APPENDIX J Proposed Landscaping: Excessive Unjustified Land Take.

3. The diagram below shows the Indicative Landscape Proposals of the Applicant and to which our Clients' have applied diagrammatic elements for ease of understanding.

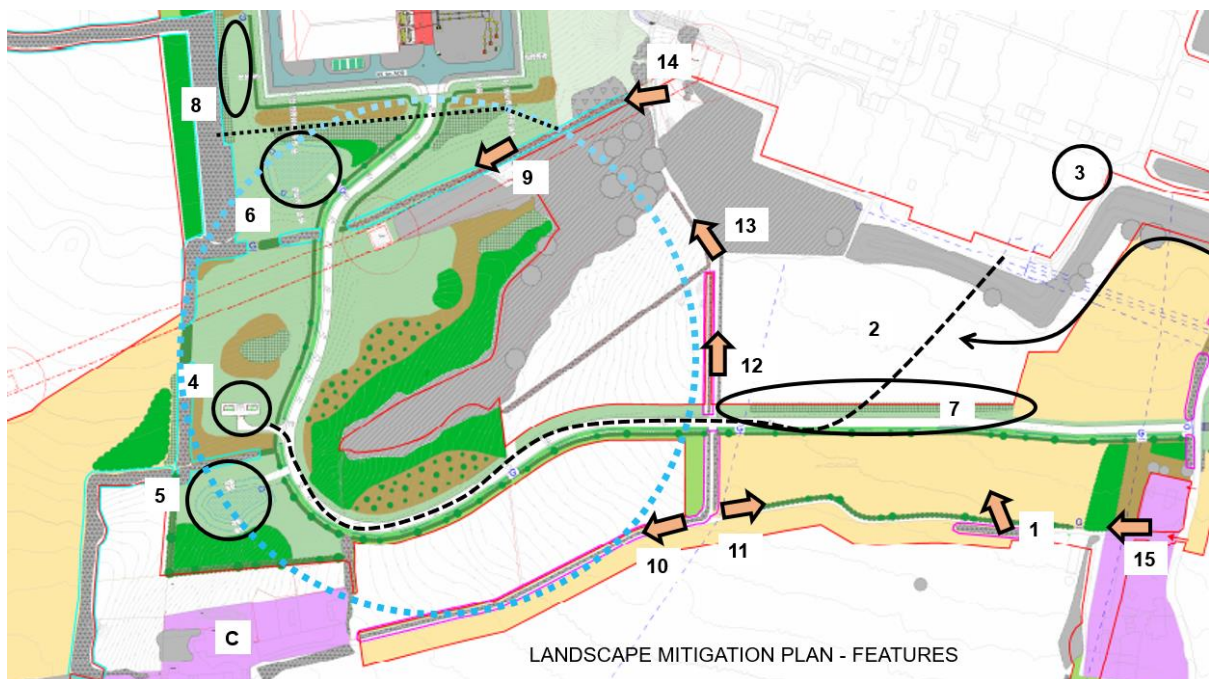
4. The starting point is that, when carefully scrutinised, the Landscape proposals that show one way that the Landscape Framework terms may result in their application, are evidently unnecessary and the extent of the Landscape proposals has been amplified. A more sustainable result can be ensured by significantly less land take and the Application development can be accomplished through significantly less onerous land enabling powers and residual emergency planning and decommissioning rights than the Applicant seeks over our Clients' land (shown

diagrammatically above essentially meaning that the area in the blue dashed circle in the diagram above can be excluded from the land take), adjacent land, and the geographical extent of those powers that are sought.

8. **Firstly**, the proposed native mixed woodland belt of up to 15m (Features Plan #7 above and Landscape Mitigation Plans APP-281 and APP-282) which is situated north of the proposed access road to the east of our Clients' land.

14. What this proposed planting strip (Features Plan #7 and shown black dashed line in the image above) would achieve, as a matter of fact, is no more than a screening of the northerly half of an existing agricultural field in the *short* highly localised view and a demarcation of the boundary of what would be a newly created smaller field. That is, a vegetated boundary would be created.

(i) The natural outcome of proposing an unnecessary permanent impermeable access way throughout the operational phase is that pluvial runoff and the topography generate a permanent need for an attenuation pond at the lowest point of the proposed access road (#5 Features Plan).

51. Adequate visual landscaping of the Converter Station S can be secured by:
 - Additional shrub planting near to the Converter Station (north of the black dotted line on the Features Plan) and positioned on any re-profiling to ensure maximum visual mitigation as soon as possible is achieved;

- Gapping up and enhancing the existing hedgerow with native trees along the existing track shown (see photo #9); and
 - Planting along the field boundary at #16.

53. A (northerly) attenuation pond could be re-shaped, fed from channels on the southern side of the Converter Station footprint and related bunding, and situated in a more north-westerly location and shaped to fit in order to avoid the compulsory acquisition of our Clients' land solely for landscape and Converter Station maintenance over the operational phase of the Application Development. See the proposed diagram.
